TO: License Fee and Accounts Receivable Branch  
FROM: Region IV - WCFO  
SUBJECT: VOIDED APPLICATION

Applicant: CTI, Inc.  
Control Number: 572220  
License No.: 50-19202-01  
Docket No.: 030-17129  
Date Voided: 4/2/97

Subject: Application for Exemption, 10 CFR Part 34.  
License number 50-19202-01

SUBJECT: TECHNICAL ASSISTANCE REQUEST; CTI ALASKA, INC.;  
LICENSE NO. 50-19202-01; CONTROL NO. 572220

GUIDE TUBE 228007

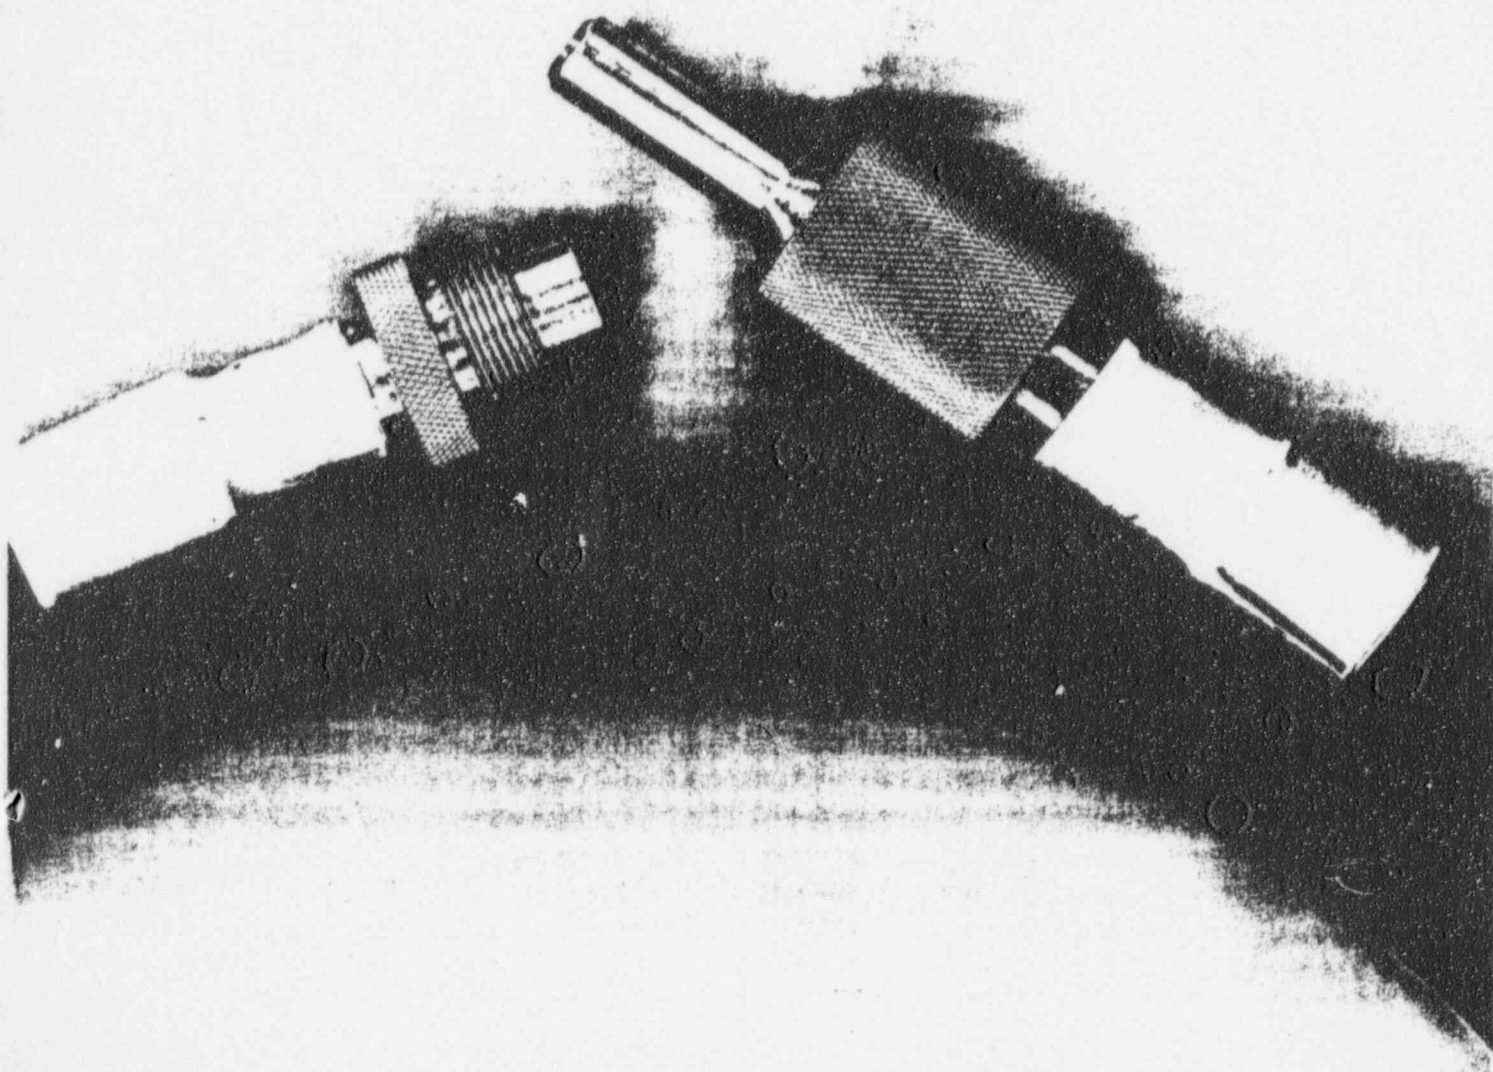
d) The SPEC 228007 source guide tube appears to be a very heavy duty constructed component.

We have tested this source guide tube utilizing one of our training (Dummy) exposure devices along with the standard source guide tubes and have noted that the SPEC tube remains flexible through various operating temperature ranges thus allowing safer radiography in the inclement working conditions that CTI Alaska, Inc. encounters.

We also noted that the SPEC guide tube end piece threads match and the heavy duty design is very rugged and it is compatible to the Amersham 660B and the INC IR-100 exposures devices. This source guide tube does not comprise safety as it meets the requirements of ANSI N432, is compatible to the Amersham 660B and the INC IR-100 devices, and appears to be better designed.

We therefore request an exemption from the aforementioned requirements and request approval to utilize the SPEC 228007 source guide tube with Amertest 660B and the Industrial Nuclear Company IR-100 exposure device systems.
